TCP/11/16(171) Planning Application 11/01223/FLL – Review of Condition 2 on planning permission for alterations and extensions to house at Knox House, Coldwells Road, Crieff, PH7 4BA

### Notice of Review supporting statement prepared by James Denholm Partnership – 20<sup>th</sup> February 2012

### Application Number **11/01223/FLL**

KNOX HOUSE – PHOTOGRAPH OF EXISTING PERTHSHIRE SANDSTONE WALLING TO NORTH ELEVATION

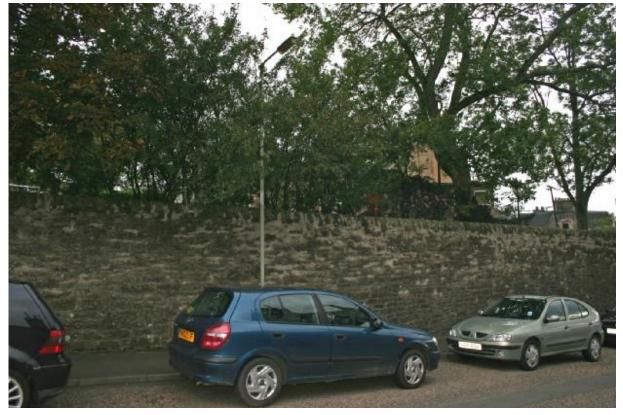
Furthermore, the north elevation, as can be seen from the photographs enclosed, is barely visible from anywhere other than within the grounds of the property and the area which is visible from outwith is not sandstone at all. It is an area of pink render above where the new porch entrance will be.

The only area of original sandstone which will be left on the north elevation after the already approved works have been completed will be approximately 50% of the elevation, which contains two large windows. The overall effect of the proposals on the north elevation as the permission currently stands will see the new one and a half storey extension in new render, butted against a narrow area of sandstone containing two large windows, butted against a new porch entrance in render with pink render/fake stone above it, butted against the blond stone of the main gable, currently concealed behind the flat roofed extension. (This blond area may become the subject of a further application to render following a full assessment of its condition, thus delivering a fully rendered north elevation to the property.)
